# Staff Report

**Item:** DR 2019-09, EXCP 2019-05, PAR 2019-02, & VAR 2019-07 "Habitat for Humanity Elm/Young Row Houses" for Tax Lot 051W17BC01100 (an unaddressed lot at the intersection of Young Street and Elm Street)

Action on a land use application, Design Review DR 2019-09, Street Exception EXCP 2019-05, Preliminary Partition PAR 2019-02, & Variance VAR 2019-07, in order to divide the subject property into three new lots and construct three attached single-family dwellings (“row houses”).

**Figure 3.01G – Local Residential Street with Parking Both Sides, 60 Foot Right-of-Way**

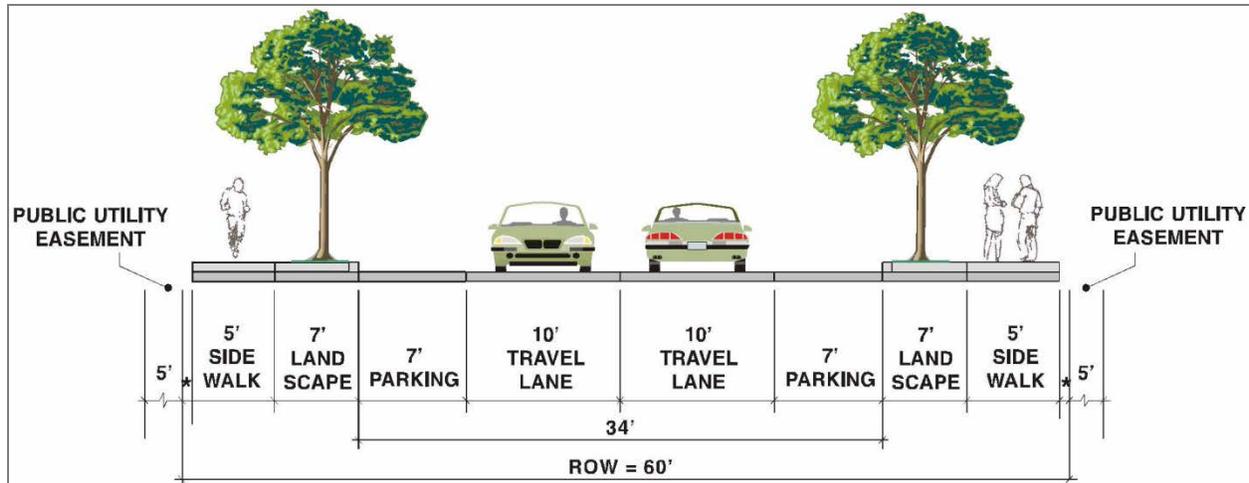
The portion of Elm Street abutting the subject property is currently a gravel street approximately 20 ft wide with no sidewalk or street trees. Total ROW width at this location is 29 ft. Per Figure 3.01G and the minimum improvements required for Boundary and Connecting Streets outlined in 3.01.03C. and D., the proposal includes the following Boundary Street improvement requirements for Elm Street:

The layout of the proposed improvements results in the sidewalk encroaching into private property approximately 2.5 ft. To address this, the applicant is proposing a modified 5-ft PUE that incorporates public sidewalk access.

In general, staff supports the Street Exception request. The required improvements add up to a total width of 41 ft whereas existing ROW width is 29 ft. This would force the applicant to dedicate 12 ft of ROW along the frontage, resulting in a lot depth of 39.79 ft and making an already-difficult property to develop significantly more challenging. The proposed improvements largely follow the standard requirements, modified to fit into the existing ROW, and would greatly increase the functionality and safety for all modes of transportation.

Because the proposed custom cross-section does not include a landscape strip, staff adds *Condition of Approval EX2* to require eight small street trees planted on private property along the Elm Street frontage. The trees are to be planted such that each of the three parcels has one tree north of and one tree south of its 4-ft walkway, with Parcels 1 and 3 both having a third tree.

EX2. Elm Street street trees: Revise plans to illustrate a total of eight small street trees planted in the westerly yards within 8 ft of Elm Street ROW and in conformance with VCA. Small size category at maturity is defined in WDO Table 3.06B. The trees are to be planted such that Parcel 1 has two trees north of and one tree south of its 4-ft walkway, Parcel 2 has one tree north of and one tree south of its 4-ft walkway, and Parcel 3 has two trees north of and one tree south of its 4-ft walkway. This is due by building permit final inspection.
